GRADING AND DRAINAGE PLAN

Clark Consulting Engineers			
19 Ryan Road, Edgewood, New Mexico 87015 (505) 281-7419			
DATE	REVISION	2404 PUEBLO BONITO COURT, NW	
		GRADING & DRAINAGE PLAN/ REPORT	
DESIGNED BY: <i>PC</i>	DRAWN BY: <i>CLC</i>	JOB No:	SHEET No:
CHECKED BY: <i>PC</i>	DATE: 12/10/93	FILE No:	1

Clark Consulting Engineers 19 Ryan Road, Edgewood, New Mexico 87015 (505) 261-7419			
DATE	REVISION	2404 PUEBLO BONITO COURT, NW	
12/21/93	Added Notes		
		GRADING & DRAINAGE PLAN/REPORT	
DESIGNED BY: <i>alc</i>	DRAWN BY: <i>alc</i>	JOB No:	SHEET No.
CHECKED BY: <i>alc</i>	DATE: 12/10/93	FILE No:	1

Lot 3
Show Basin Boundary

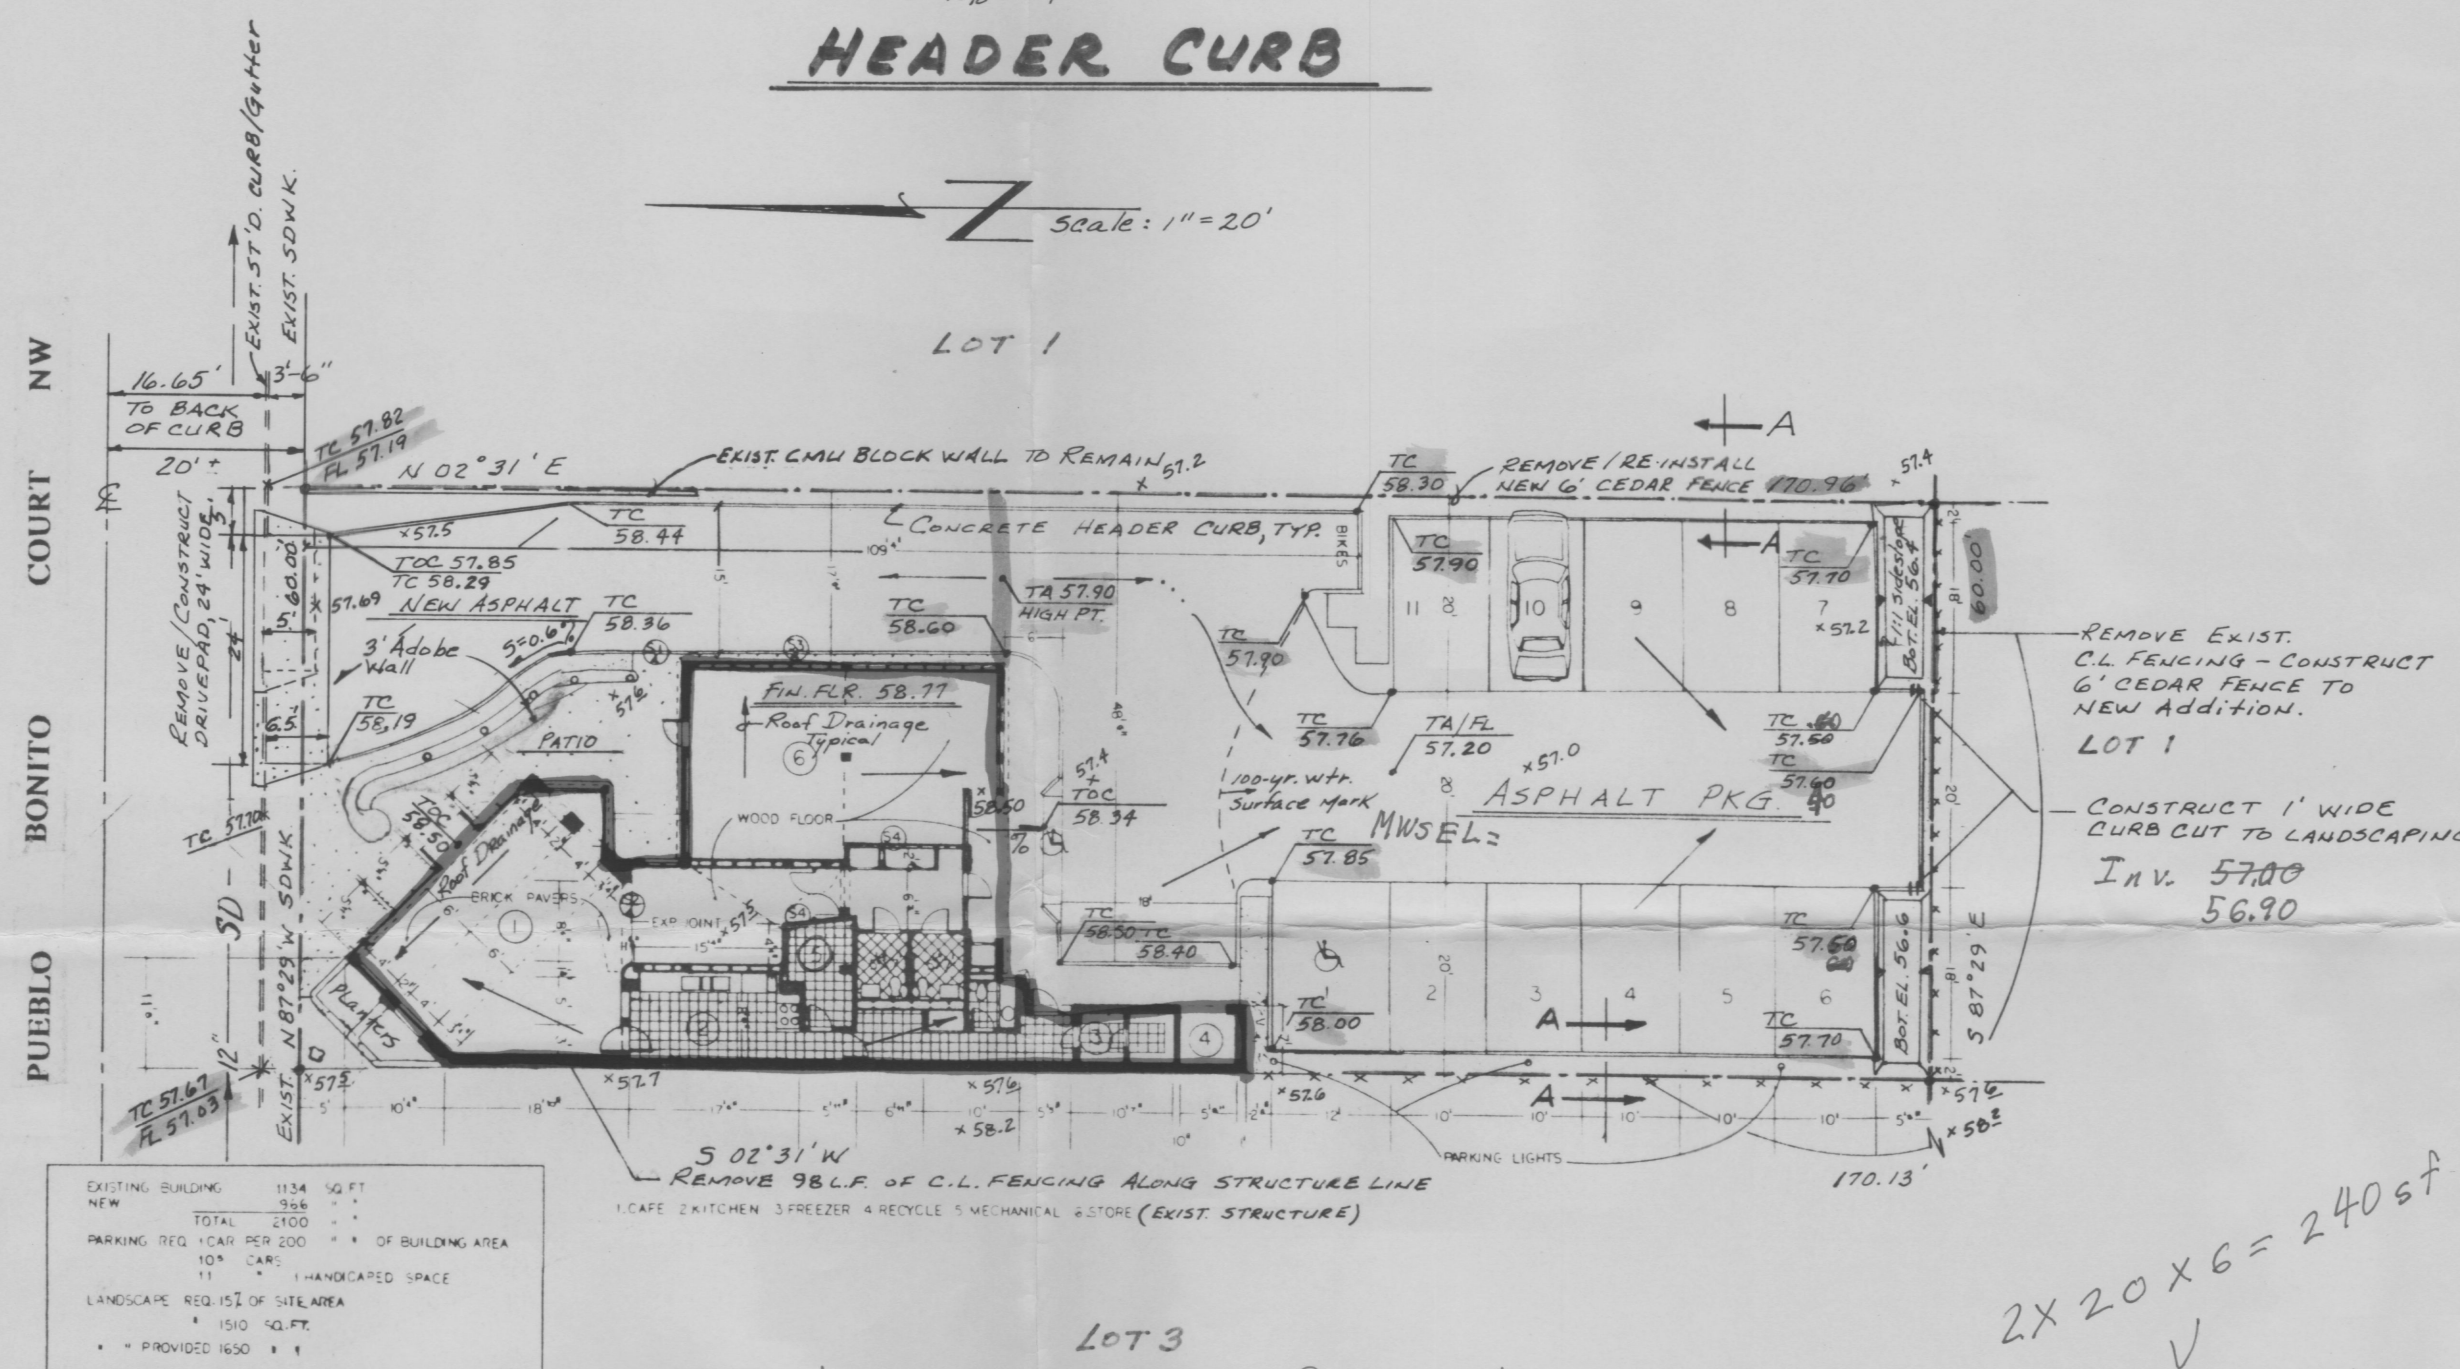
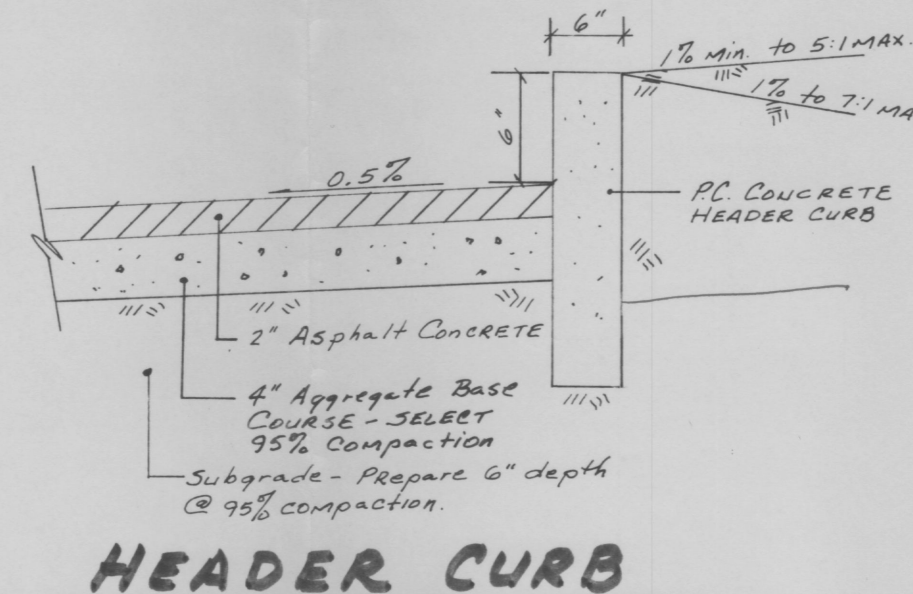
$$\frac{99}{171} (1578) = 914 \text{ cf}$$

GRADING AND DRAINAGE PLAN

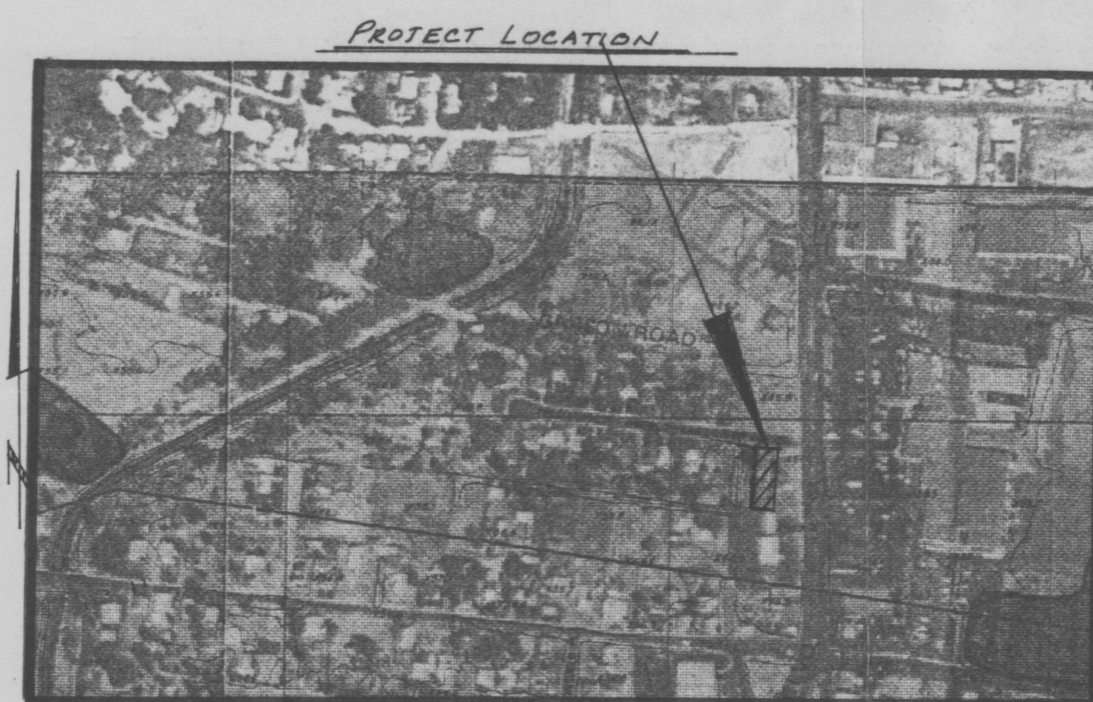
DETERMINE REQ. VOLUME (10-DAY) IN PARKING LOT

$P_{10-day} = 3.95"$ AREA_{ROOF/PAV.} = $105' \times 56' \div 43560 = 0.14$ AC ≈ 5880 sq

$VOL_{10-day} = VOL_{360} + \frac{5880 \times (3.95 - 2.35)}{12} = 1057 + 784 = 1841$ C.F., REQUIRED ✓

$VOL_{provided} = 40.6$ S.F. (X-section @ South end of PKG. LOT) *
 88 FT. $\div 2$ (wedge shape)
 $= 1766$ C.F. ≈ 1841 , OK
